HOLLAND FW351 Fifth Wheel Product Update Notice

Product: FW351

Model: XA-351-A

Part No: CAST XD-351-H

New Style FW351 Fifth Wheel (D=190kN)

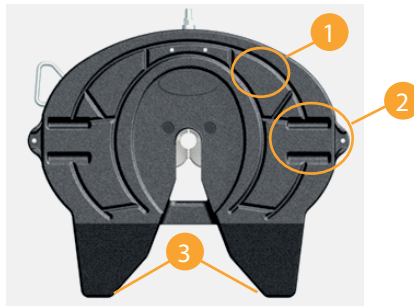
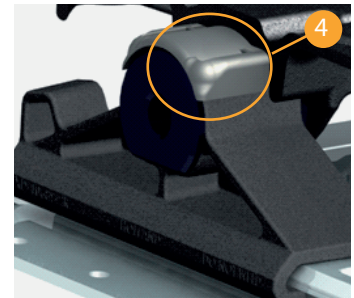
The new style FW351 fifth wheel can be visually identified with the following changes:

1. Cast steel top plate surface (no longer machined);
2. Larger grease grooves above pocket area for improved grease retention;
3. Wider throat area, designed to assist drivers when coupling;
Improves the kingpin target by a further 20%;
4. One piece replaceable lube free pocket inserts which eliminate the need for routine greasing;

Due to the latest design changed, SAF-HOLLAND is in a position to increase the rating of the **FW351** fifth wheel from D=165kN to **D=190kN** in the following installation options:
